ADDENDUM NO. TWO (2)

IFB# 15104

PARALLEL TAXIWAY & LOCALIZER RELOCATION at the SUFFOLK EXECUTIVE AIRPORT

June 24, 2015

Sheet 7, View 2 - Exhibit 1
Suffolk Executive Airport

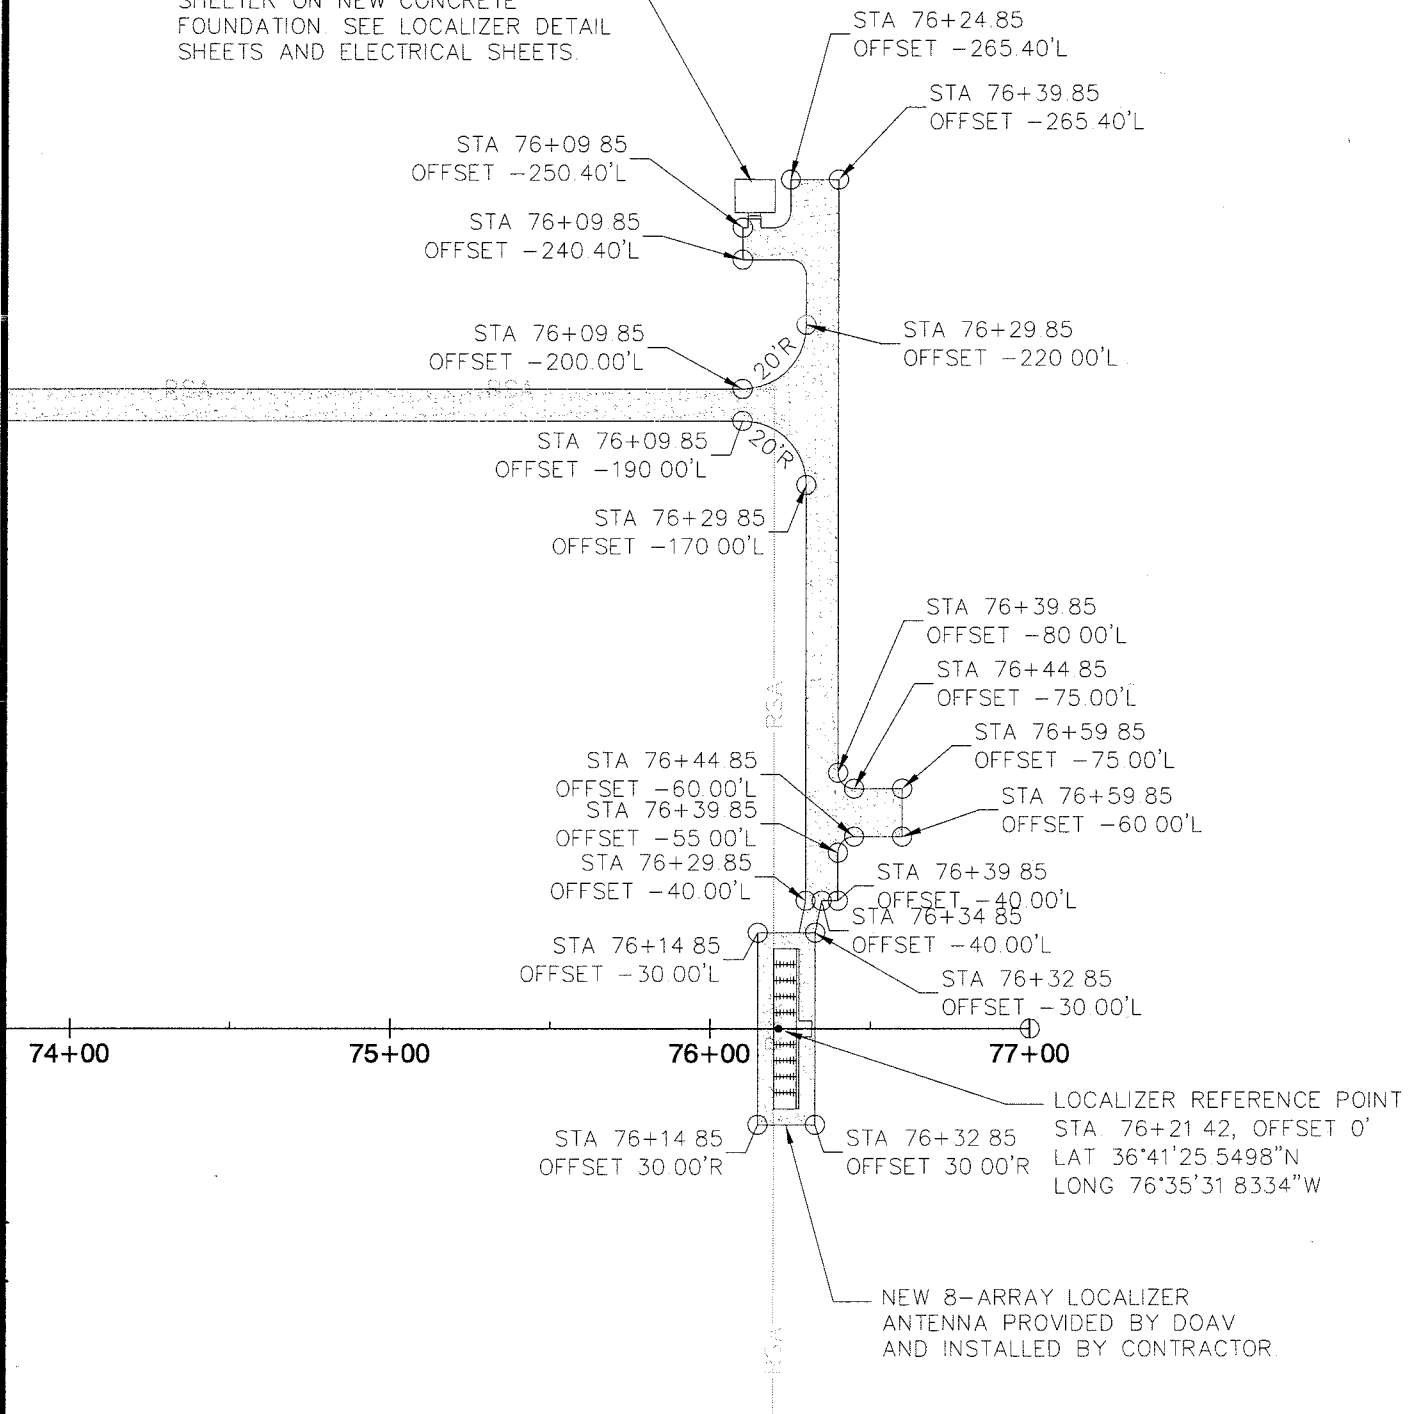
View 2 – the location of the relocated localizer shelter has shifted approximately 40' to the northwest. Please see exhibit included as Attachment "A" of this Addendum No. Two (2). Reference is also directed to the project specification PSP-12 Miscellaneous Demolition for any clearing and grubbing required.

RELOCATED LOCALIZER EQUIPMENT
SHELTER ON NEW CONCRETE
FOUNDATION SEE LOCALIZER DETAIL
SHEETS AND ELECTRICAL SHEETS.

Sheet 14 - Exhibit 1
Suffolk Executive Airport

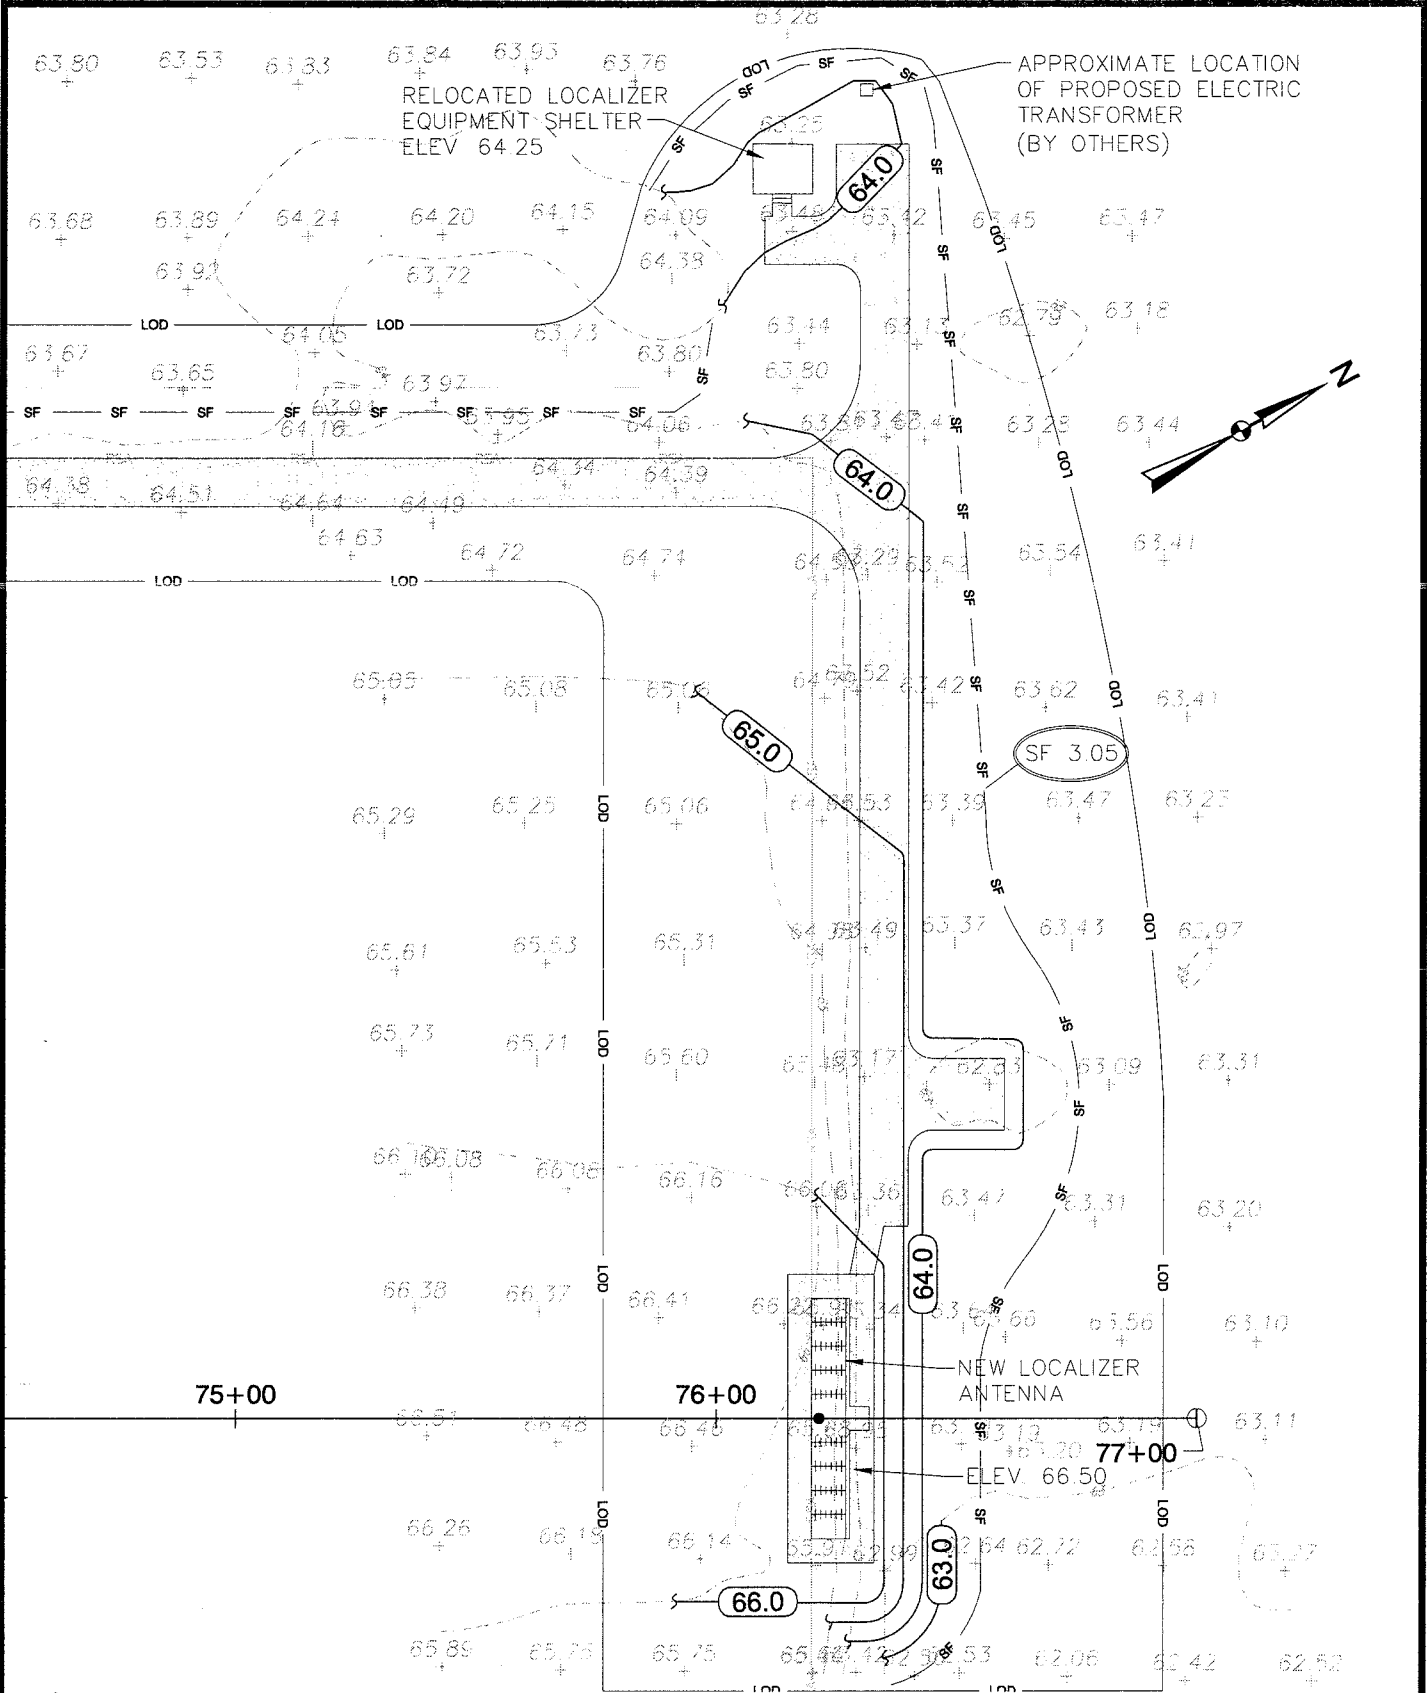
The location of the relocated localizer shelter has shifted approximately 40' to the northwest. Please see exhibit included as Attachment "B" of this Addendum No. Two (2). Reference is also directed to the project specification PSP-12 Miscellaneous Demolition for any clearing and grubbing required.
